CITY OF PORTLAND, MAINE

AGENDA PORTLAND PLANNING BOARD MEETING

To: Maggie Stanley, Chair and Members of the Planning Board
From: Austen Torres Davis, Planner
Date: February 4, 2022
Re: Major Site Plan & Conditional Use Application – 386-392 Saint John Street
Project #: PL-001684-2021
Meeting Date: February 8, 2022

Comments from Planning Staff & Peer Reviewers.
 PL-001684-2021 – 392 St. John Street – Multifamily Residential

First Floor Plan Comments

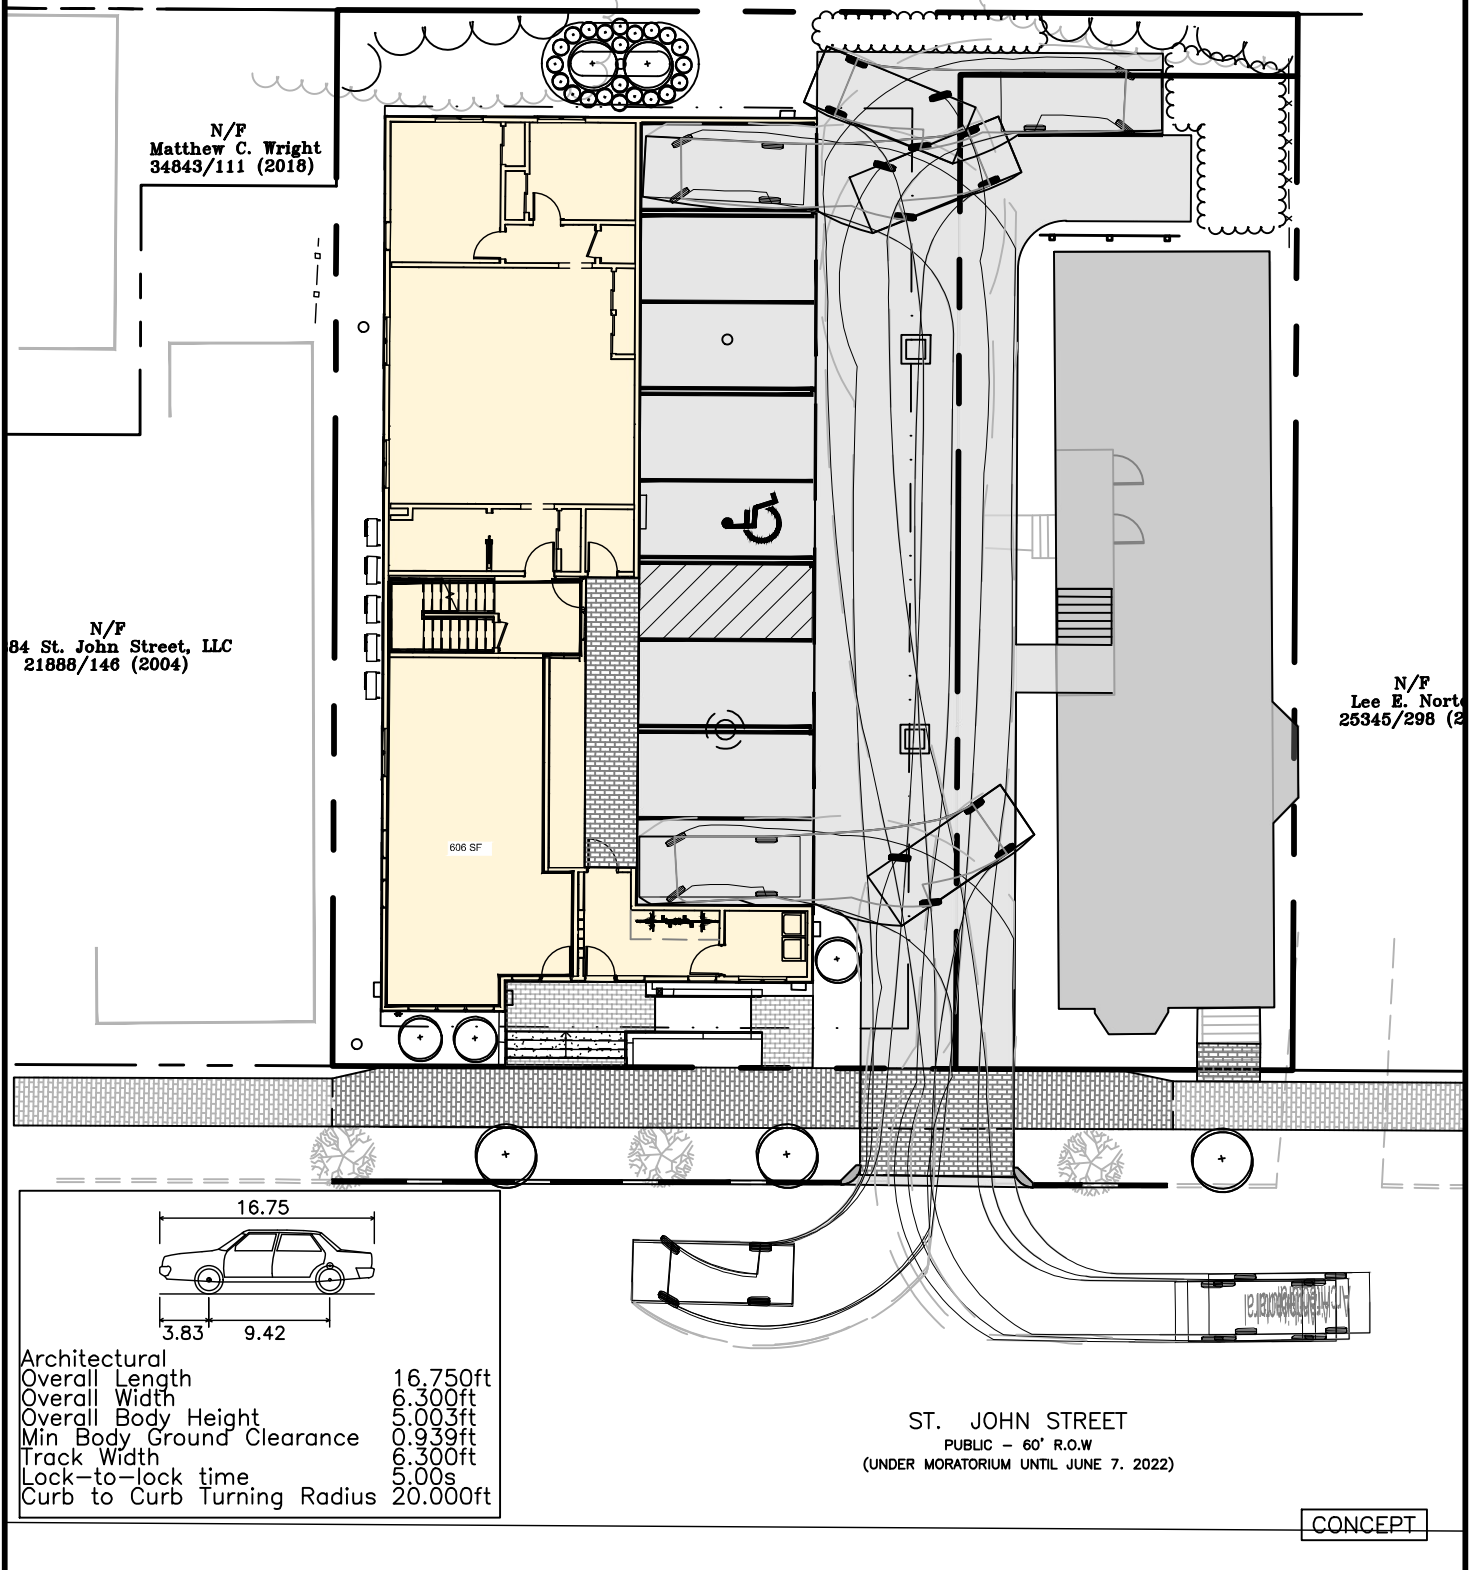
- Parking space: ADA space is between column lines E and D. There is no column obstructing this space. See comments under circulation on page 1.
- Door: The door has also been relocated adjacent to the walkway.
- Bathroom: Note the dashed fixture clearances on plan illustrating compliance. -Turning radius: There are 5'-0" turning radius at bottom and top of ramp.
- Rail: There are handrails on both ramp and stair which include 1'-0" rail extensions at top and bottom per code outside the turning radius.
- Mechanical exhaust: Mechanical engineer will confirm compliance with exhaust standards.
- EV charger placement: EV charger is placed adjacent to the access aisle to prevent non-compliance with amenities provided for accessible spaces inaccessible spaces.
- Basement: No tenant amenities in basement just building sprinkler riser.

Thanks for your feedback.

Figure 6. Site & Landscape Plan of 386-392 Saint John Street

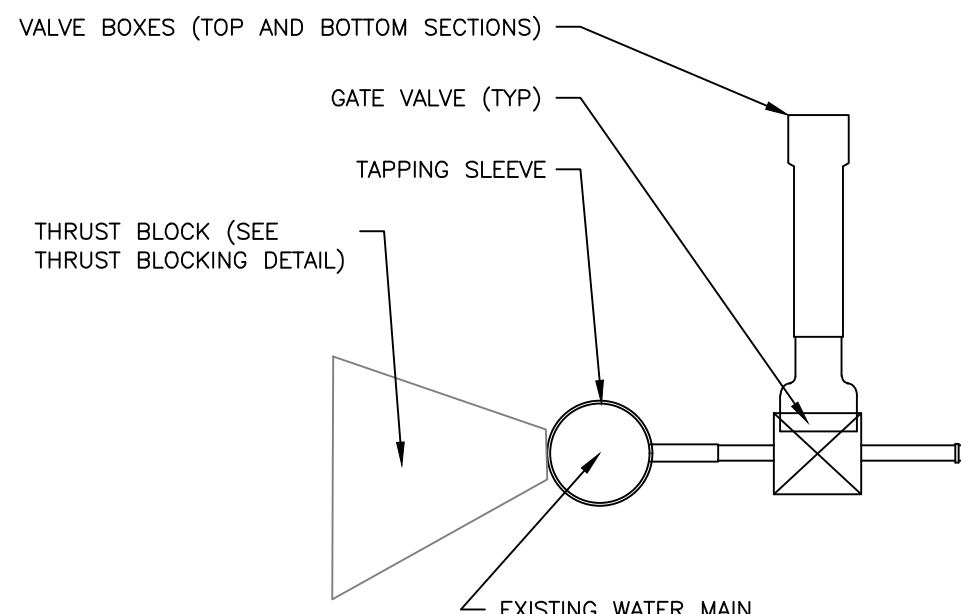
Site & Landscape Plan does not match the First Floor Plan, as the doorway adjacent to parking space #4 are shown with slightly different dimensions.

It should be shown on the plans how the applicant is meeting the required 20% open space.

An EV charger should be included in this development but is not shown in plans.

Response – The space and bulk table located on Sheet C-10 has been updated with left and right setbacks for each lot.

Response – The building footprint for the existing building onsite is 1,812sf, (we are unable to update the Energov manually). Please refer to the space and bulk table located on Sheet C-10 for the landscaped open space ratio.

Response – A table has been added to Sheet C-10 that outlines the impervious area coverage for each lot.

Response – An EV charger has been implemented into the site design. Please see Sheet C-10 for additional information.

C-20

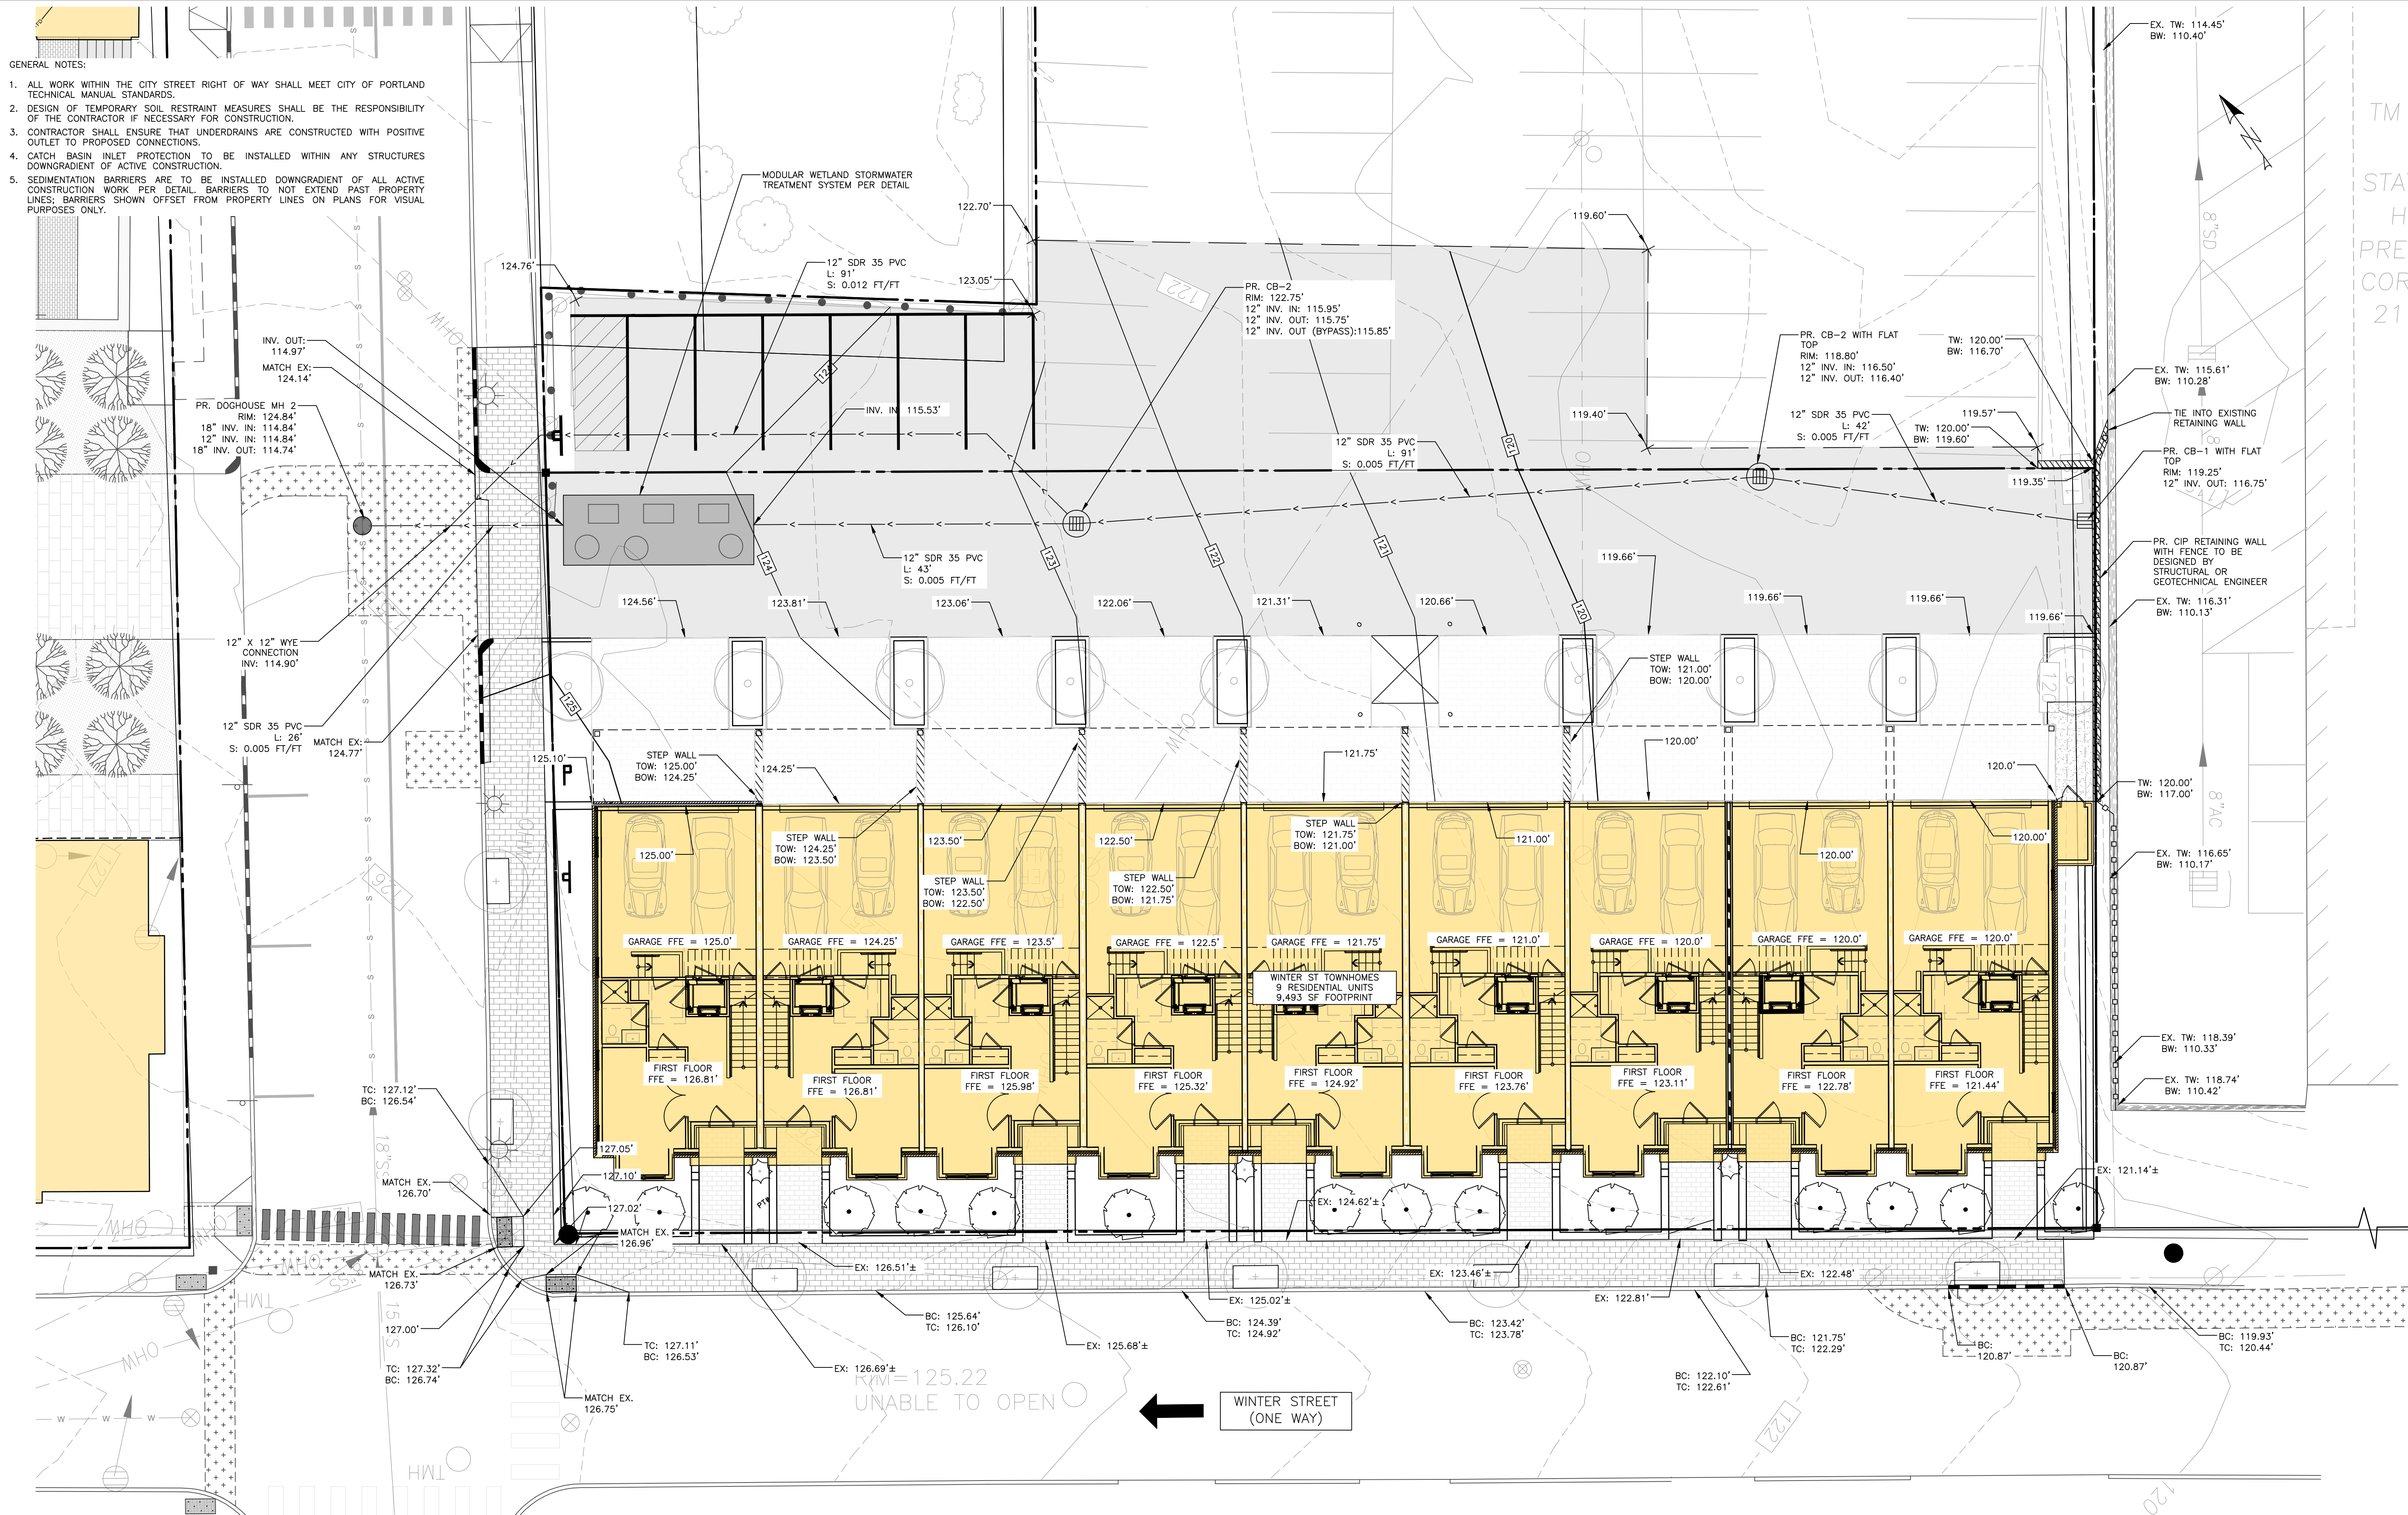
Sewer laterals should be indicated in utility plan. The utility plan shows where this is located but not where it is connected to the house.

Response – A sewer lateral connection to the structure has been incorporated. It should be noted that this final location of the sewer lateral will need to be confirmed by MEP. Please see sheet C-20 for additional information.
